# PlanGrid Task Report - Aug 1, 2024

Prepared by Michael McDonnell

Aug 1, 2024

## #352 [UNIT 510][NEW] AC-1 Gas Inlet Grommet

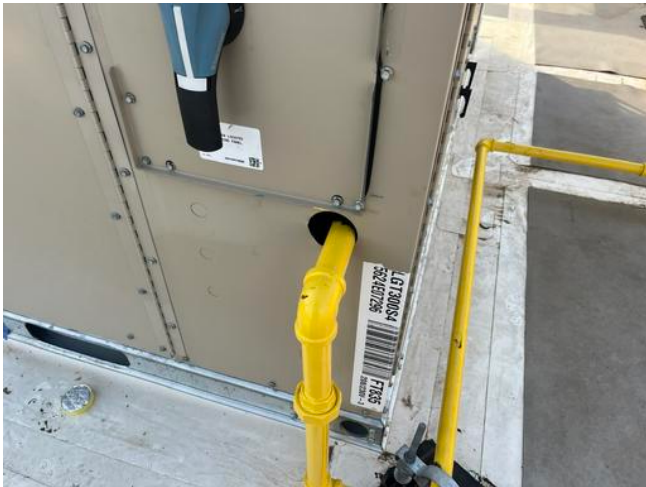
AC gas inlet grommet is missing at the gas line/RTU connection.

**#351 [UNIT 505][NEW] Equipment wiring portals.**

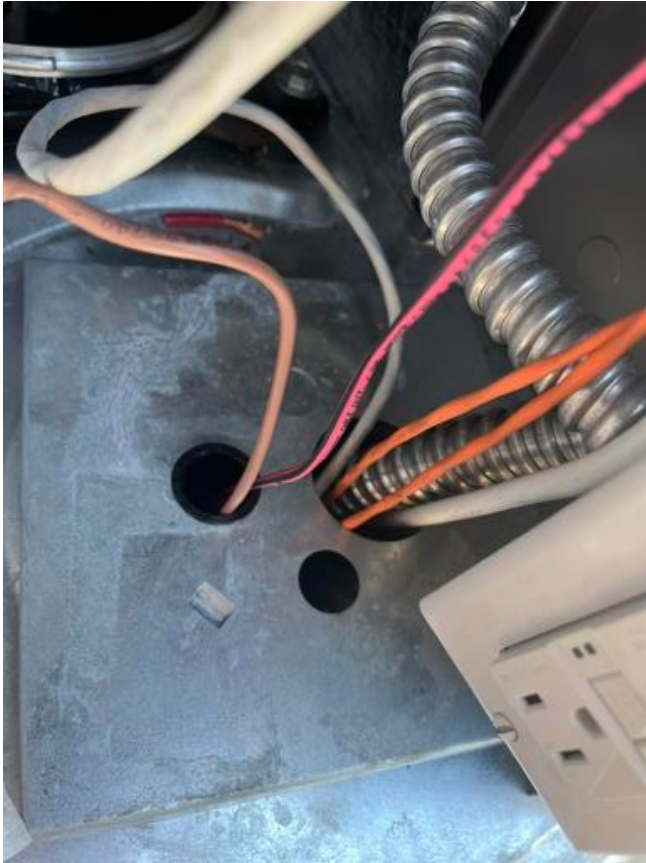
Equipment wiring portal missing or not utilized correctly. Low voltage wiring grommets missing for sensor wiring to ACs. Specifically on AC-4. Recommend all other units verified to have grommets installed.

## #350 [UNIT 504][NEW] Equipment Fresh Air Tempering

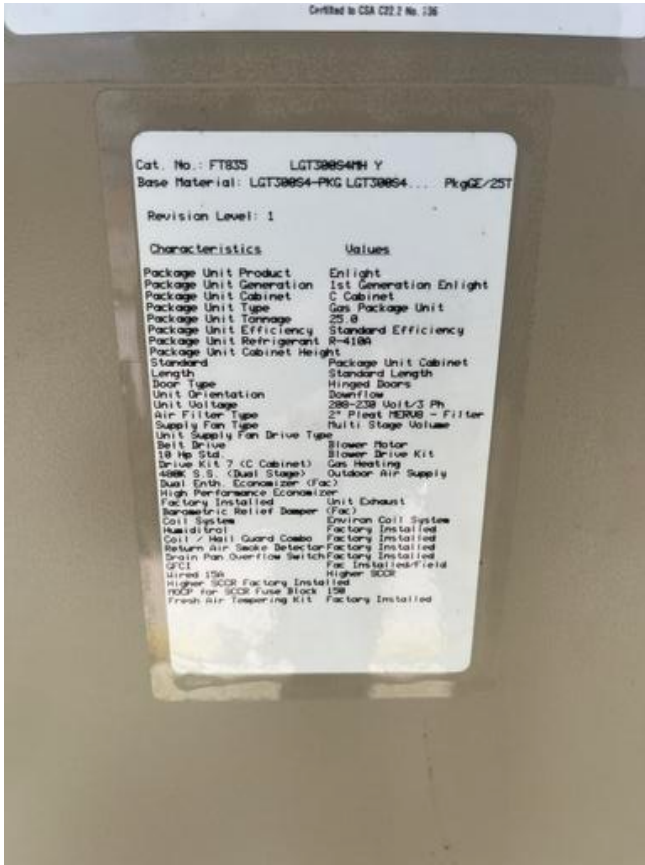
All ACs are to have FAT per schedule. Discharge sensors still need to be installed per specification on ACs 1,2, and 5. Lennox parameters set, but recommend verification.

## #346 [CNTL 999][NEW] AC-5 Sensor Location

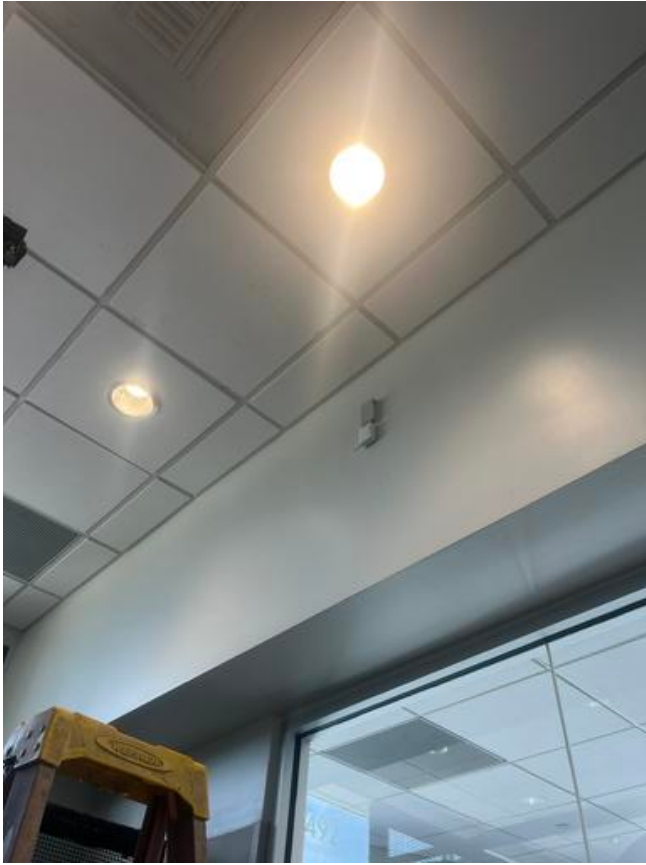
AC-5 sensor mounted at ceiling height. Sensor should be at 5'0". Per MC, unable to route to wall at that height. Seek approval. Recommend offset adjusted for temperature reading if left in place.

**Sheet**  
P4.1

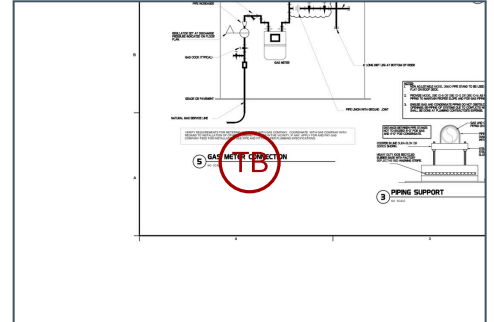
See condensate specs. T-fitting open to atmosphere needs to be below connection to AC unit.
